UNITED STATES PATENT AND TRADEMARK OFFICE

| APPLICATION NO. | FILING DATE | FIRST NAMED INVENTOR | ATTORNEY DOCKET NO. | CONFIRMATION NO. |
|--|-------------|----------------------|-------------------------------|------------------|
| 10/696,054 | 10/28/2003 | Allan M. Fredholm | SP02-215 | 5918 |

| Office Action Summary | Application No. 10/696,054 | Applicant(s) FREDHOLM, ALLAN M. | |

- 1) ☒ Responsive to communication(s) filed on 12 November 2006.
- 2a) ☒ This action is **FINAL**. 2b) ☐ This action is non-final.
- 3) ☐ Since this application is in condition for allowance except for formal matters, prosecution as to the merits is closed in accordance with the practice under *Ex parte Quayle*, 1935 C.D. 11, 453 O.G. 213.

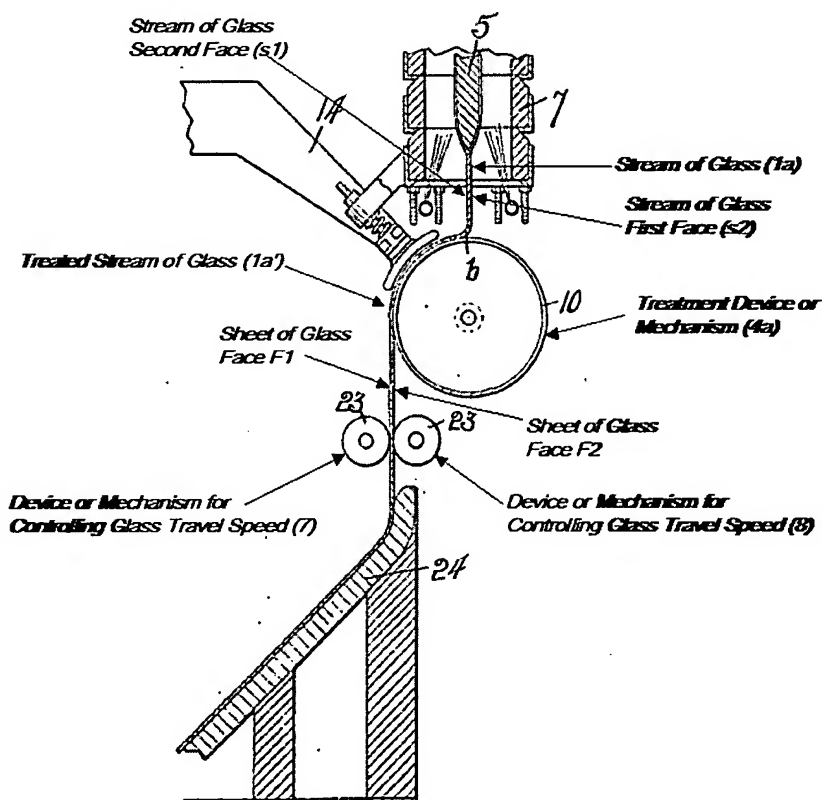
Claims 1, 8, 9/1, 9/8, 12, and 13 are rejected under 35 U.S.C. 102(b) as being anticipated by Danner (1,674,856). The particular elements of Danner that apply to the immediate claims are set forth with particular reference to the composite excerpt from Danner Figures 4 and 5 as presented below and as labeled in accord with the applicants terminology.

1. The sheet of glass has two faces, face (F1) and face (F2) wherein one side of said sheet (F1) presents a "hardened skin surface which will prevent it becoming marred". In the context of the present claim this glass sheet presenting an unmarred, "hardened surface skin" is held equivalent to a sheet of glass with at least one of said faces presenting "a high surface quality"

2. A stream of glass (1a) delivered which has a first face (s2) and a second face (s1), and each face is free from making contact with any surface as evidenced in the region of the s1 and s2 lead lines by the above figure.

3. The first face (s2) of the stream of glass is placed into contact with a treatment device or mechanism (4a) while maintaining at least a central strip of the second face (s1) of the stream of glass (1a) free from any contact with any surface. The immediate reference indicates (pg 2, Line 53-54) that the sheet is deflected by the roll or "treatment device or mechanism (4a)" and passes around and down one side thereof which is understood as equivalent to the claimed process of supporting the weight of said glass and accompanying the falling movement of said glass.

4. A device or mechanism for controlling glass travel speed (7,8) acts upon the treated stream (1a') (pg 3, Lines7-8)
5. The glass sheet is thereafter conveyed into a leer or annealing chamber which is understood to effect the "cooling of said sheet of glass" as claimed (pg 2, line 55)

1. the delivered stream of glass (1a) is received on the surface of a "treatment device or mechanism (4a)" as indicated in parent claims or a "roller (4a)" as indicated in the immediate claim.

4. From the figure, it is evidenced that there exists no relative displacement of the stream (1a) relative to the surface of the "roller (4a)" and that contact between the stream and the roller is maintained over a "significant" fraction of the circumference of said "roller (4a)"

5. The roller is associated with a "Device or mechanism for controlling the surface temperature of the glass sheet" which in the above figure is understood as equivalent to the air-blast nozzle (14) as set forth by

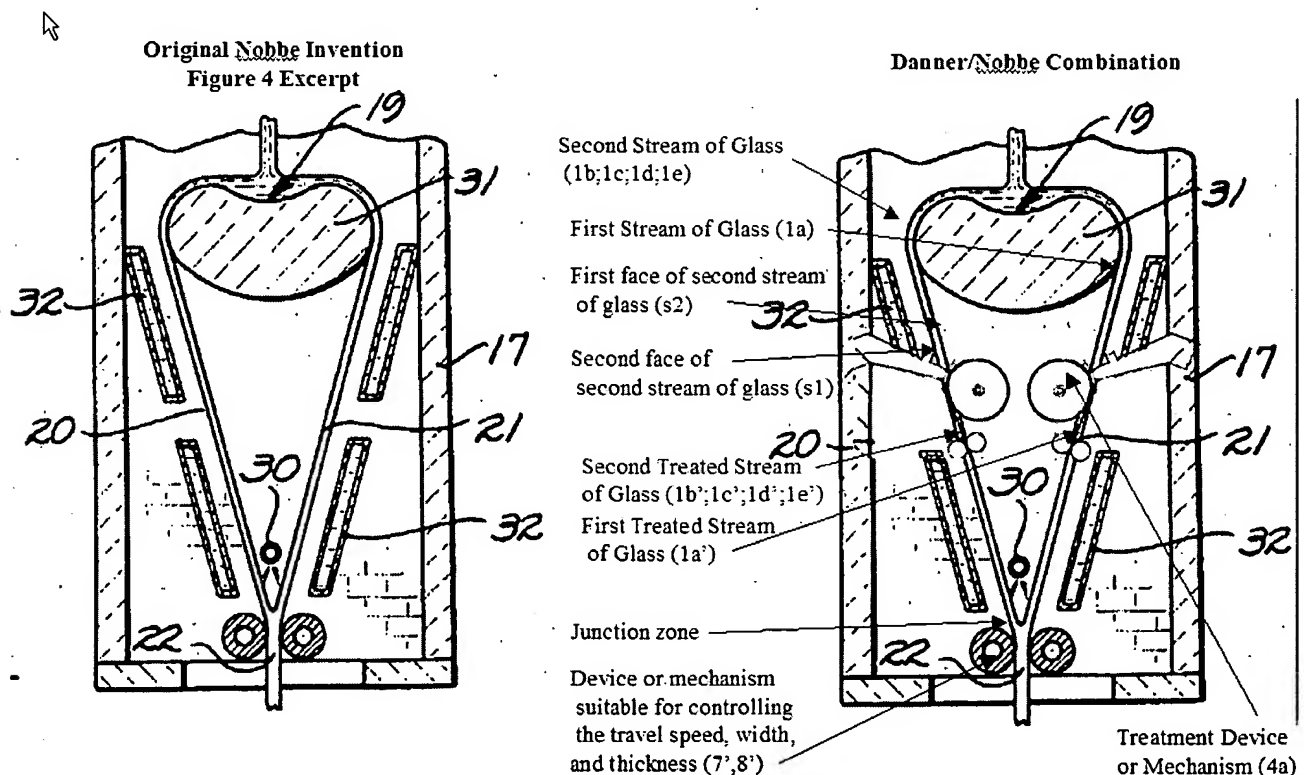
Nobbe broadly teaches of a method for the continuous production of glass sheets from molten glass wherein films of glass flow downward from a molten source while remaining substantially free from contact until being joined or laminated in a junction zone. The following two figures indicate the invention according to Nobbe Figure 4 and the obvious combination of inventions from Danner in view of Nobbe which will be described below. The combination image has been annotated for reference and clarity in the context of the presently claimed invention and will be referenced as such. It is further understood that while the combined invention as depicted applies the Danner invention both the first delivered stream of glass and second delivered stream of glass, said teachings could obviously be incorporated individually to either of the two streams and to the exclusion of the other.

1. Delivering "a second stream of glass (1b, 1c, 1d, 1e)" which by virtue of existing in the same process is understood to be compatible with the first stream of Glass (1a). The second stream of glass (1b, 1c, 1d, 1e) has a first face and second face (s1, s2) as indicated above. Both of first and second faces of both the first delivered stream and second delivered stream are held free from contact with any surface from their formation in the region of the slab (31) and the treatment device (4a).

4. First and second treated and guided streams are joined via the first face of the of the first treated stream of glass that has come into contact upstream with said treatment device or mechanism 4a while the second face of first stream remains relatively free from contact with any surface. Further, device or mechanism (7', 8') is applied to said two joined together streams of glass.

Claim 20 is obvious in light of the objection to Claim 14 above wherein the two sheets of glass are delivered from a single source indicated by (19) in the combined figure

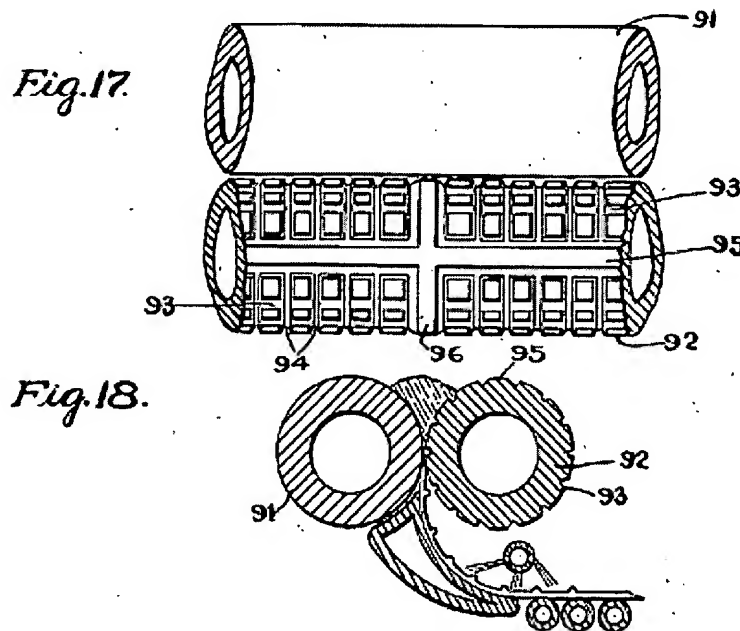
Danner-Nobbe fails to indicate that the second stream of the two streams should be treated by subjecting the second face of the second stream of glass to an action by another device or mechanism which, co-operating with the treatment device or mechanism serves to transfer an imprint onto said second face. Gelstharp teaches (see

figure 17 and 18 below) of a cooperating set of devices which serve to transfer an imprint to one side of a sheet of glass. It would be obvious to incorporate the cooperating devices as taught by Gelstharp in lieu of or in addition to the airblast nozzle (14) in treating the second sheet of glass in order to obtain a patterned surface on the exterior surface of the produced sheet of glass.
